ADDENDUM NO. 2

PLYMOUTH MUNICIPAL AIRPORT NEW ADMINISTRATION BUILDING

FMA PROJECT NO: 1098-05

Issued: April 3, 2018

2 SITE ELECTRICAL DETAIL

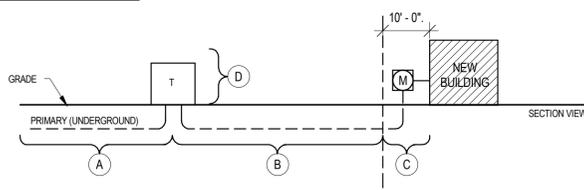
Item 1.3 **QUESTION:** Section 011000-10 notes that telephone/data, fiber, communications, and security systems are furnished and installed by the owner. Plan E-000 notes to provide a wall mounted rack and E-701 notes rack by others. Division 27 specs and plan E-000 seems like the electrical contractor has to install a complete tel-data system. Can you please confirm if the tel-data and fiber systems are furnished and installed by the owner's vendor?

ANSWER: Telephone, data and electrical service is brought to the building by others. Electrical Contractor is responsible for telephone, data, and electrical service within the building and within 10' of the building per Detail 2 on E-011. Airport security and communications equipment scope is described on drawing A-692 and E-701. The wall-mounted rack described on E-000 is different then the IT rack shown in detail 2 on E-701.

Drawing No.:
E-011

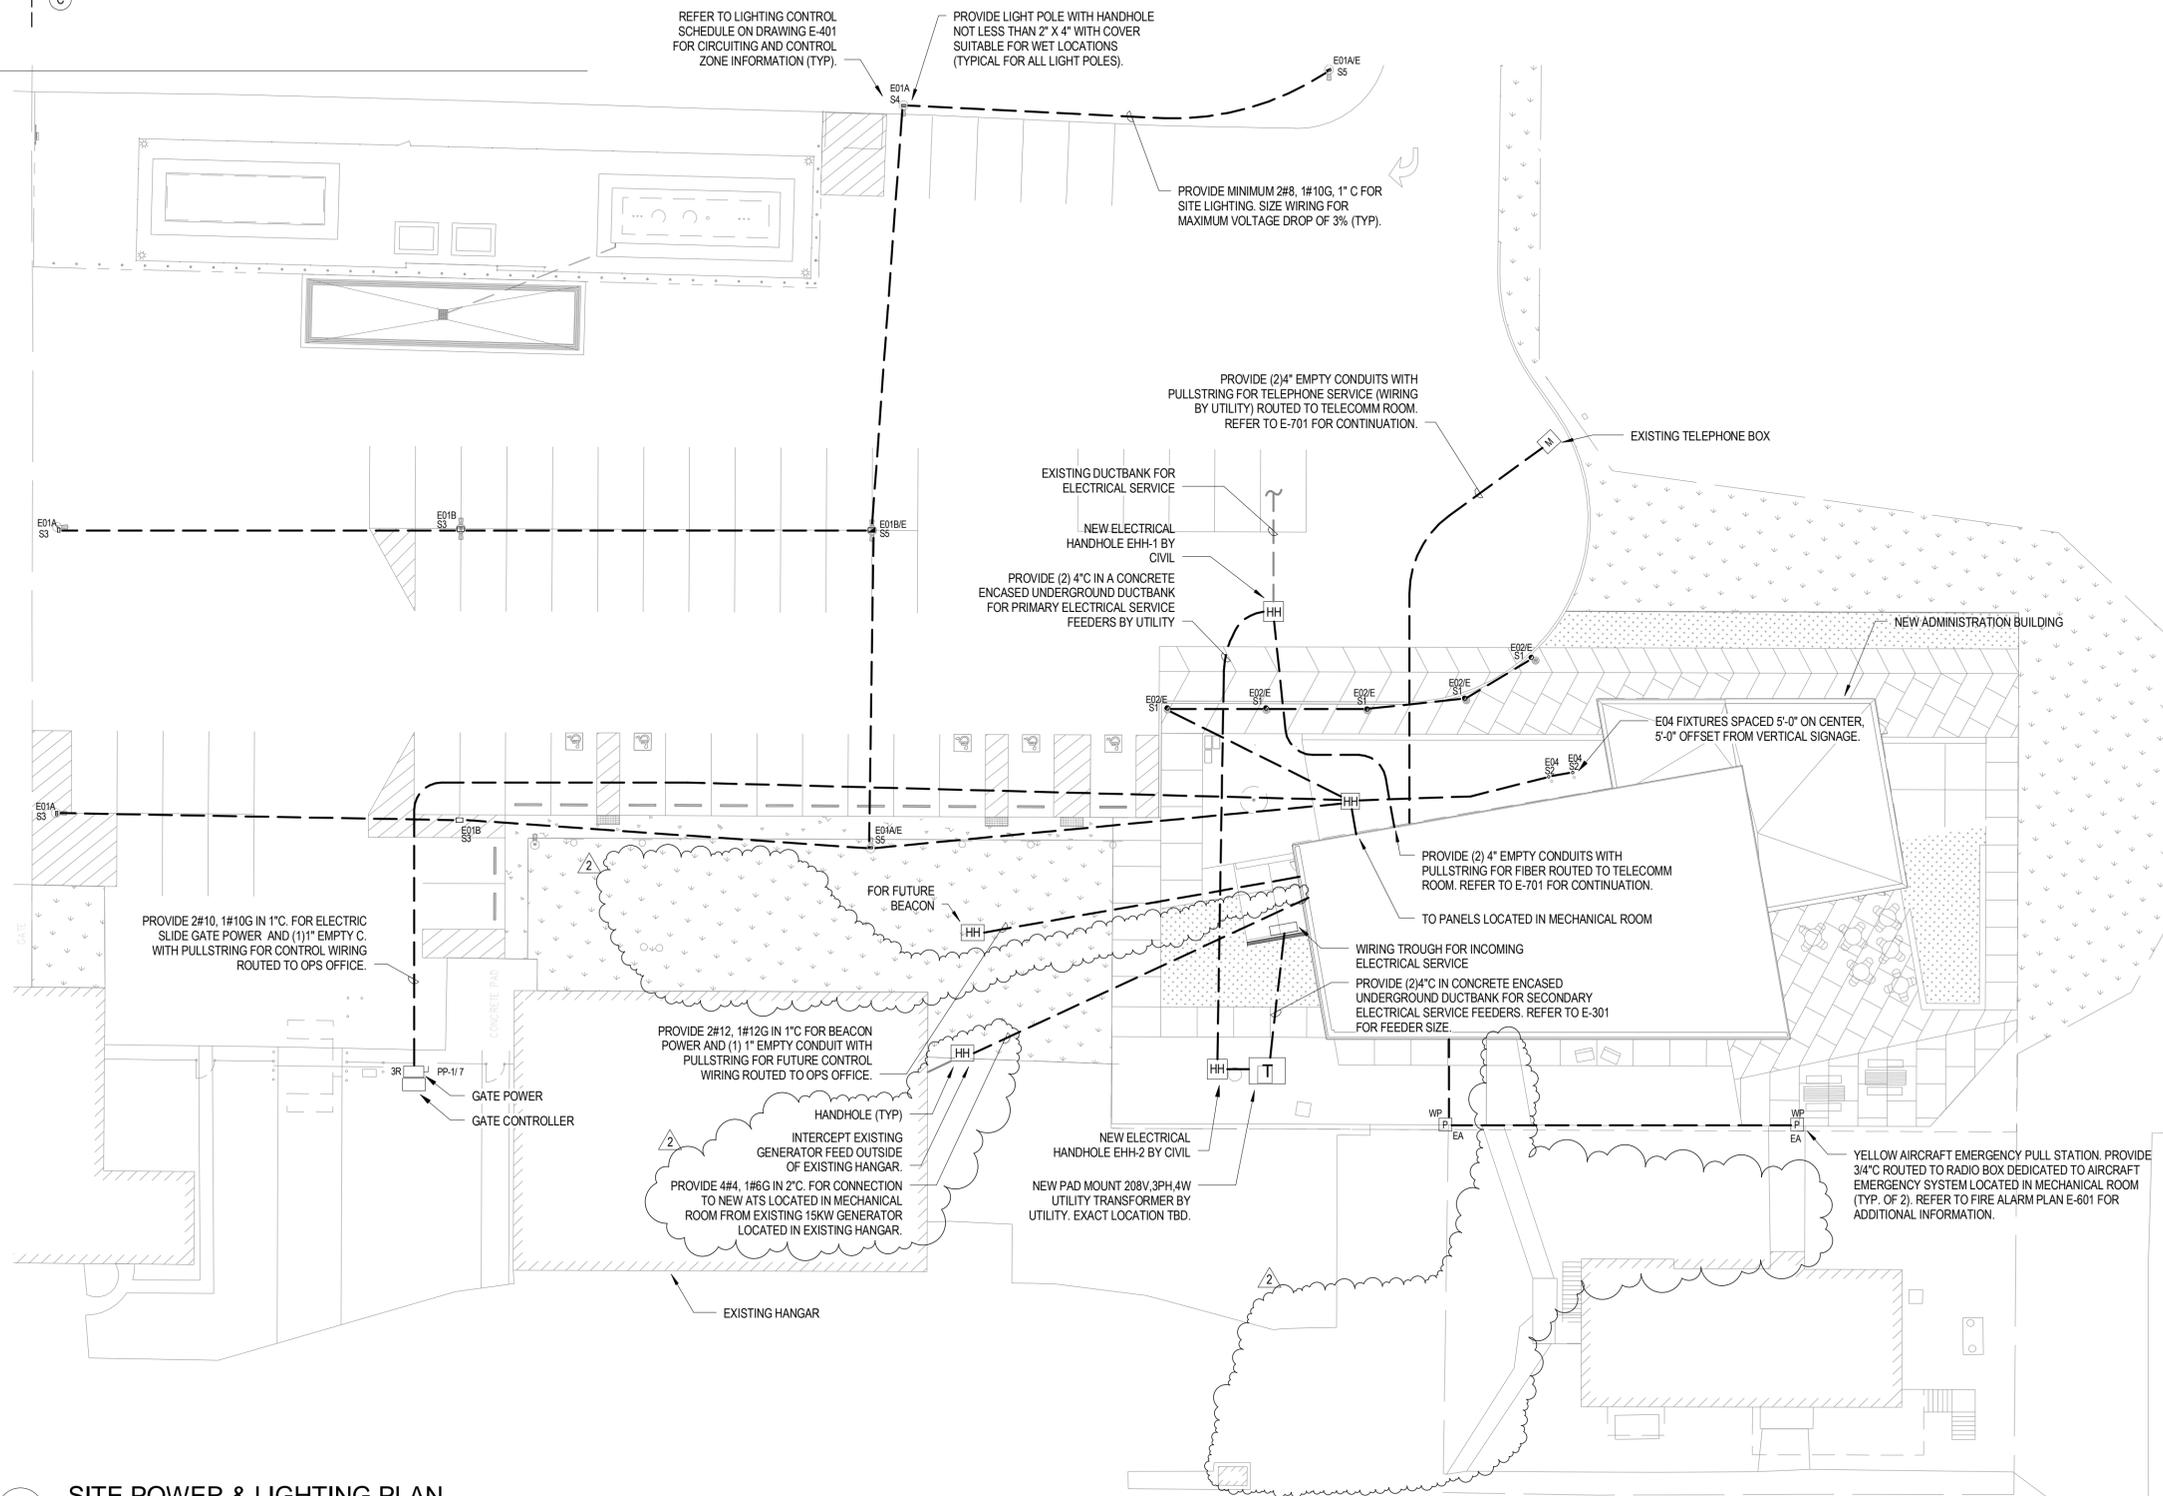
<i>Number</i>	<i>Description of Changes</i>
ELECTRICAL	
E-011	Delete scope of intercepting and extending existing telephone service near existing hangar to telecom room. Delete scope of providing handhole to intercept and extend existing power and control wiring for gas pump. Add note to intercept existing generator feed outside of existing hangar to clarify scope. Add handhole outside of existing hangar.

Item 1.4 **QUESTION:** On drawing E-011, new Electrical Manhole EMC-1 indicates (2) 4" conduits for Fiber/telcom...(this manhole is also indicated for the primary electrical service) Please advise / clarify.

Item 1.5 **QUESTION:** On drawing E-011, the new Electrical Manhole EMC-1 indicates connection to existing duct bank for the electrical service. Who is responsible to cut into the existing duct bank which appears to be for the primary electrical service.

Item 1.6 **QUESTION:** Drawing E-011 indicates a new handhole to intercept and extend telephone service. New conduit & wire shall match existing. Please state what the existing conduit & wire is.

Item 1.7 **QUESTION:** Drawing E-011 indicates a new handhole to intercept and extend power and control wiring for gas pump. New conduit & wire shall match existing. Please state wiring is required.

Item 1.8 **QUESTION:** Drawing E-011 shows an existing Generator is located inside the existing hanger. Please provide the current location within the hanger. Please advise / clarify who is responsible for the sawcutting and concrete removal within the existing hanger for the associated generator work.

ANSWER: The existing condition has the primary electrical service and fiber optic service in separate conduit, but sharing the same duct bank.

ANSWER: Connection to existing duct bank by General Contractor. Refer to detail 2 on E-011 and revised specification section 26 05 43.

ANSWER: Work deleted from scope, refer to revised E-011.

ANSWER: Work deleted from scope, refer to revised E-011.

ANSWER: General Contractor to intercept existing generator duct bank outside of Hangar building, refer to C-9.
